41 Hutchins Drive

Bld. Addition and Amendment

Woodard + Curran

**PROPOSED SITE PLAN**

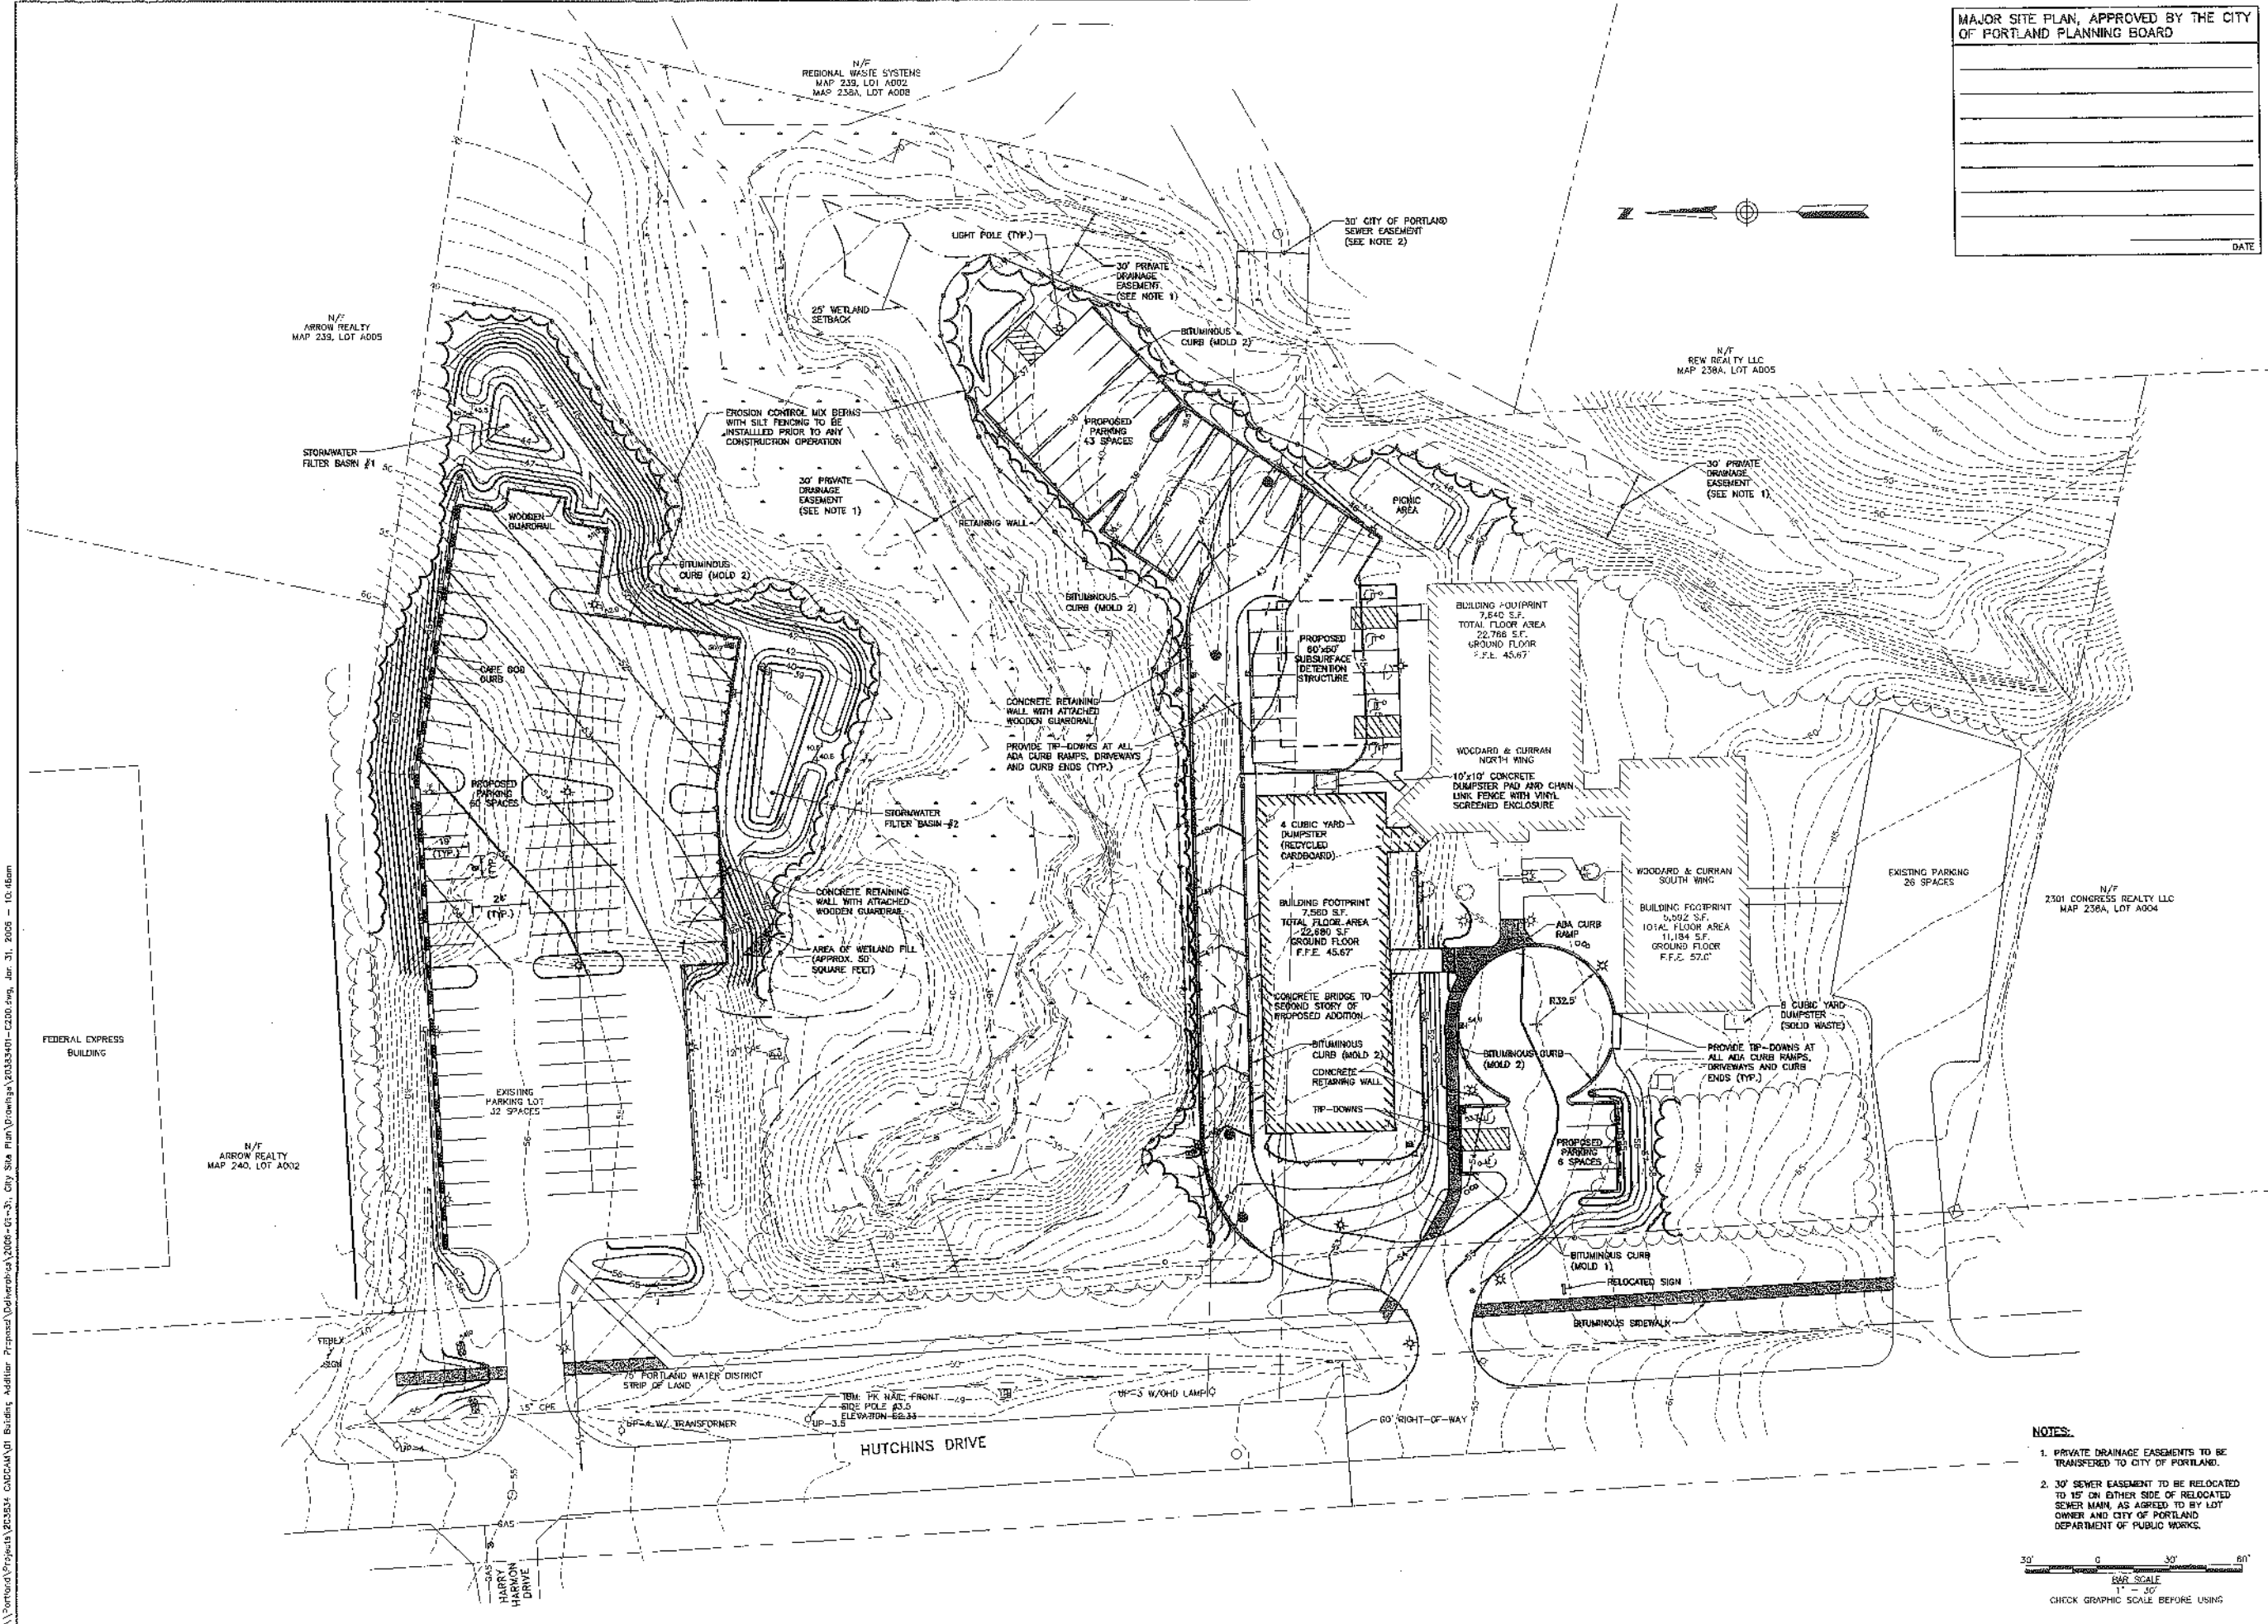
Curbing along the access drive has been extended toward the entrance where the road curves and runoff velocities are expected to be higher. No curbing is proposed where the drive takes a straight course, in order to encourage some amount of filtering as runoff passes through the landscaped area. These changes can be seen on Sheet C201 Proposed Site Plan.

Cape Cod curbing has been added to the internal parking lot islands in the north parking lot, as can be seen on Sheet C201 Proposed Site Plan. Through discussions with the Development Review Coordinator, the Cape Cod curb detail has been revised to provide a one foot curb width rather than a two foot width. The revised detail can be seen on Sheet C301 Civil Details 2

Snow storage areas have been added to Sheet C201 Proposed Site Plan. The 20 foot driveway width will be maintained; no snow storage is proposed for along the roadside.

**LANDSCAPE PLAN**

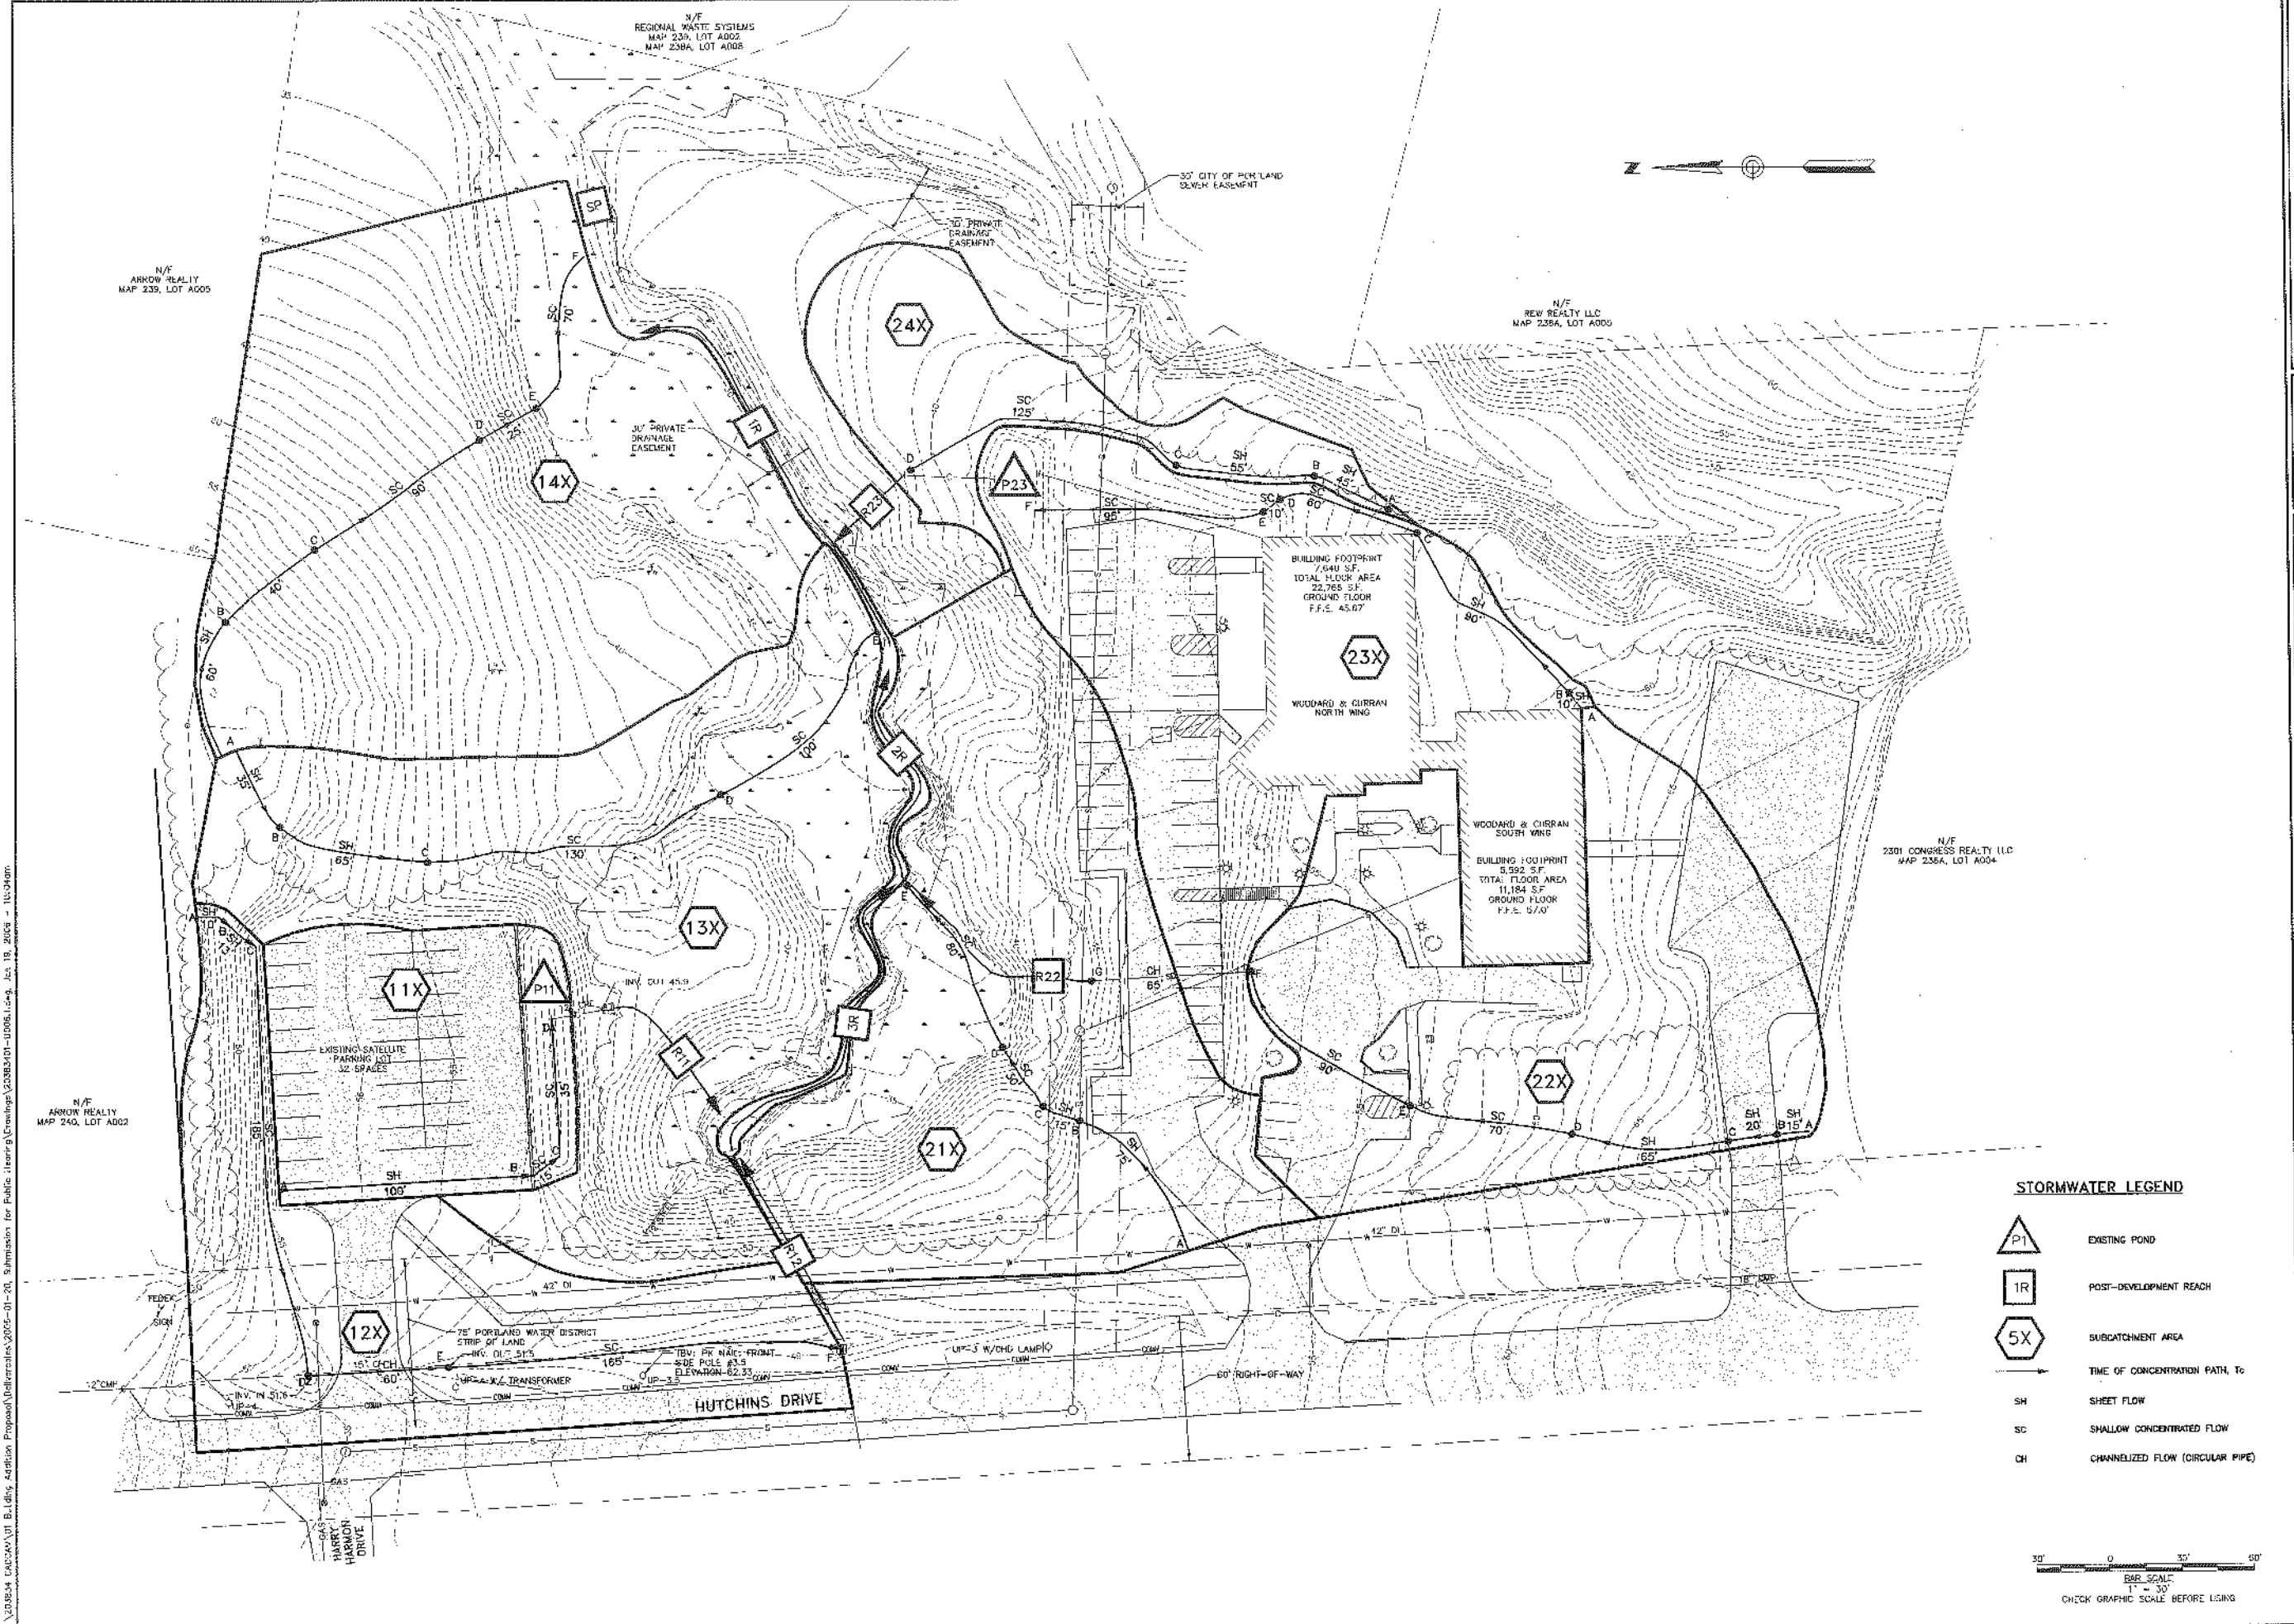
Jeff: the Landscape Plan doesn't address some minor issues I raised such as screening the dumpsters, why a paved area in the circle, need to screen rear of retaining wall guardrails...and I would have thought they could do more planting around the new area of 8 parking spaces to the south...

The Landscape Architect for the project, Pat Carroll of Carroll Associates, Inc., has discussed the project with the City Arborist. At this point we believe we have adequately addressed all comments. The design is depicted on Sheet L-1.0 Landscape Plan, which has been attached to this submission.
